THE GORDON BUILDING

Building Shell Eart
Repair and Restic
for Historic
Gordon Building

State Historic Preservation Office Review & Recommendation Sheet

CONDITIONS SHEET

A FIRST FLOOR RESTORATION PLAN: REPAIR AND IMPROVEMENTS
 SCALE: 1/8" = 1'-0"

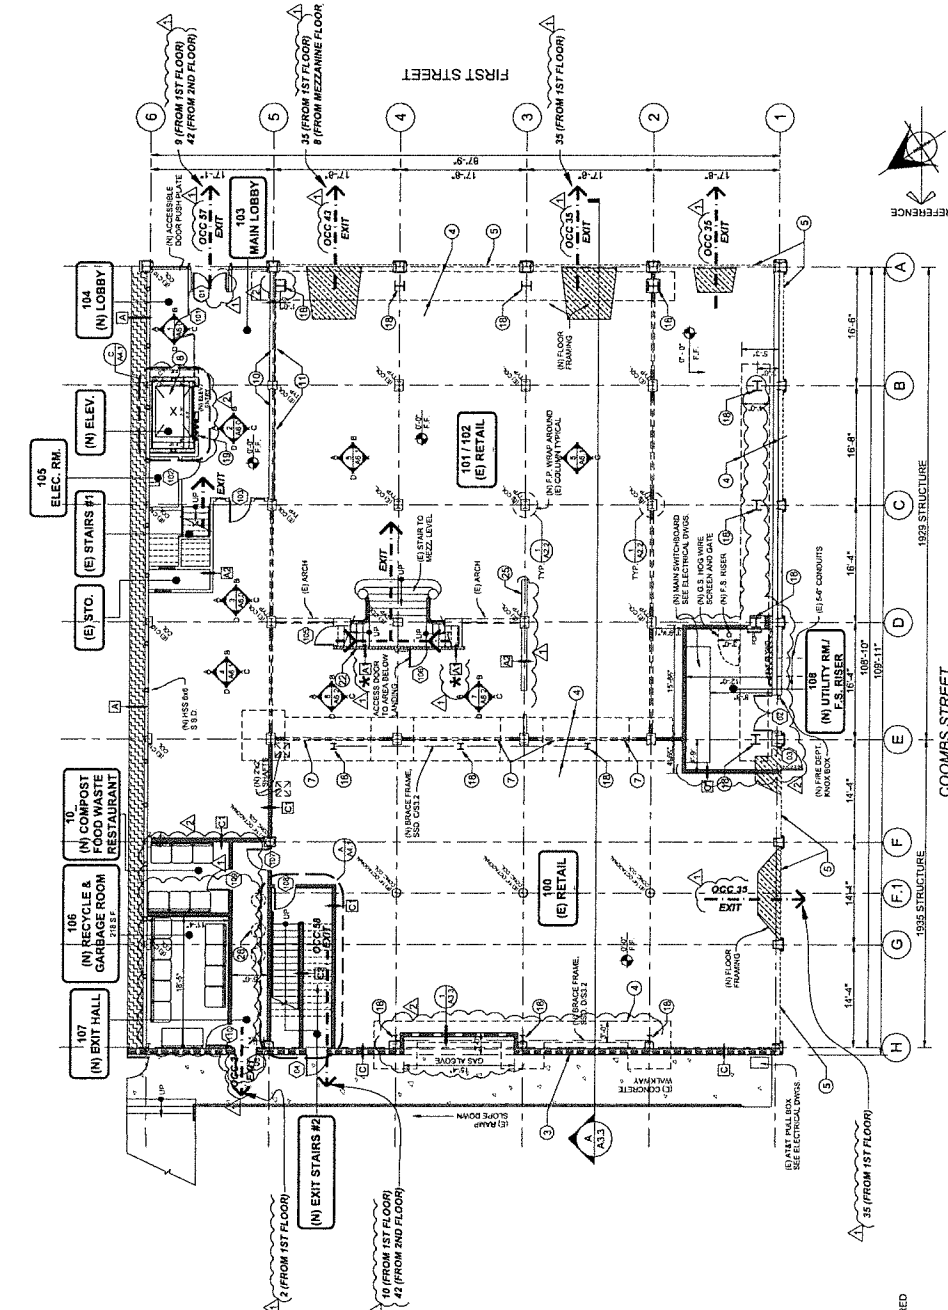
Mezzanine and ornamental stair:

The current proposal abandons the mezzanine in place due to the cost of making the mezzanine accessible. The ornamental stair is retained with barriers provided at the top. The floor/ceiling assembly, walls and partitions at the mezzanine are removed, and a soffit is created around the perimeter to reference the former ceiling and floor planes. The ornamental plaster molding proposed to be repaired at the mezzanine ceiling level can then be seen from the first floor. The inclusion of the light well square footage at the second floor removes the natural light source from the extant skylight, which is an additional defining feature of the mezzanine space.

Based on the submitted information, the mezzanine must remain intact even if accessibility is not provided. Existing character-defining features and fabric

characterizing the mezzanine must remain in place. The skylight opening must remain but artificial light may replace the natural light lost.

The disuse of the mezzanine level does not justify the removal of original fabric or the loss of the character defining space and does not meet Standard 2. **See Conditions.**

Visible new structure:

As submitted, the moment frames at column lines 1 and A do not meet the Standards. New structural work must be concealed to the extent possible.

- The moment frames are very visible inside and outside at the first floor due to their depth, which obscures the upper half of clerestory windows at three bays of column line 1 and three bays of column line A.
- The moment frames intersect with and connect to existing ornamental plaster finished steel beams. The architectural finish treatment of this intersection, including repairs to the ornamental plaster and how it meets new construction is not detailed.
- Diagonal and angle bracing at the underside of the second floor diaphragm is visible and the fire protection and concealment of structural elements is not shown on the reflected ceiling plan.

Note: Consider placing the moment beam between the clerestory window and the storefront window and concealing the beam inside the existing soffit. This may eliminate or reduce moment structure at the ceiling level.

Provide a structural alternative that would eliminate or reduce visible impact of the structure at the first floor clerestory windows and resolve existing plaster ornamental work with the new structure compatible with the character of the property. **See Conditions.**

Work of concern:**Column line 3 wall at first floor:**

Column line 3 was the former demising wall of the retail space that centers the mezzanine in that space. The wall has been modified since, and the current proposal removes the recent column enclosures and remaining wall, creating stand-alone columns.

The retention of existing wing walls at column line 3 would recall the former demising wall and visually re-center the mezzanine in the retail space. The wing walls may additionally serve another function as the demising plane for column capitals, since only

the half of the columns facing the retail space have an ornamented beam and column capital. There is no evidence from the photos submitted and the original drawings that the other side of the column and beam are ornamented. **See Conditions.**

1. The second floor corridor must remain intact. Retain and repair the second floor corridor including all doors, trim, borrowed light window openings and other character-defining features.
2. All character-defining features of the mezzanine must remain intact such as the floor, walls, plaster cornice and ceiling plane including a recessed skylight. Provide a compatible light source for the ceiling recess.
3. Provide a more compatible structural scheme that reduces visual impact to the ground floor, and conceals the visibility of the moment frame to the extent possible.
4. Retain and repair wing walls at column line 3 at the first floor.
5. Replace in kind all wall finishes removed for structural inspection for walls to remain.

SECOND FLOOR RESTORATION PLAN: REPAIR AND IMPROVEMENTS
SCALE: 1/8" = 1'-0"

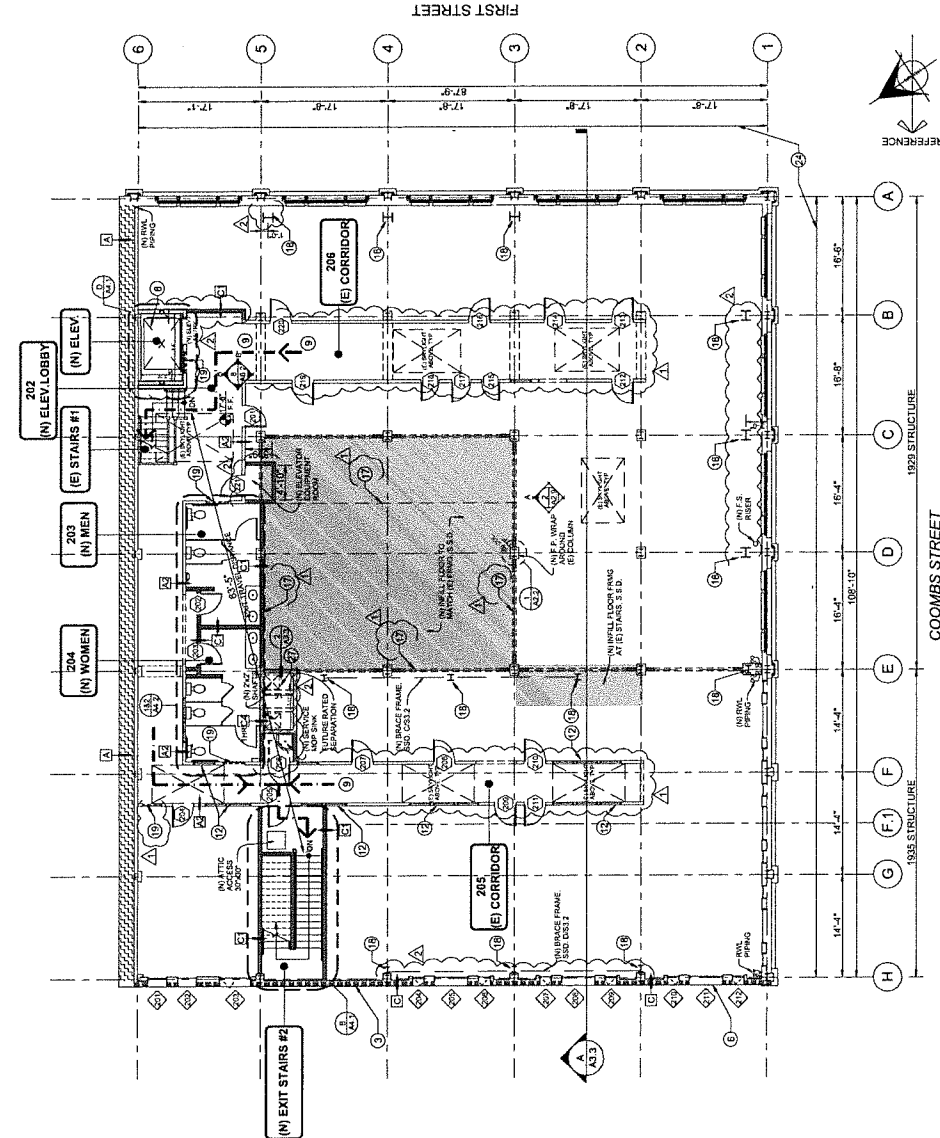
STATE EVALUATION OF PROJECT AND CONCERNS:**Work that does not meet the Standards:****Removal of second floor corridor:**

The application states that the intent is to modify the existing 1929 and 1935 second floor to meet modern needs and desires of tenants that seek a more open floor plan with the options to reinstall portions of the walls if needed. The applicant proposes to remove all the walls at the second floor and build back walls at the corridor locations with punched openings to suggest the original location of the corridor. Hardwood flooring distinct from existing hardwood flooring would delineate areas where walls used to be.

The second floor hollow clay tile corridors are largely unchanged from 1935, with the exception of the west corridor along Coombs Street. The corridor plaster wall finishes and the hollow clay tile walls behind the finishes have sustained limited damage from the earthquake as shown on some second floor photos. The damage as documented appears repairable, and does not justify complete removal.

As discussed during the site visit and restated in the follow-up letter dated May 18, 2017, and as expressed in the RFI dated May 31, 2016, and as noted in the National Register nomination, the second floor public corridors are original to 1929 and the 1935 expansion and are almost wholly intact, with the exception of the west corridor noted above.

The intention to provide open space in anticipation of tenants' needs does not meet Standards 1, 2 and 6. Standard 1 requires a compatible use for the space. Standard 2 avoids removal of character-defining features and spaces. Standard 6 prioritizes repair of the feature, or replacement to match the visual qualities and materials where possible.

The second floor corridor must remain in place unless sufficient documentation is provided to justify its removal. **See Conditions.**
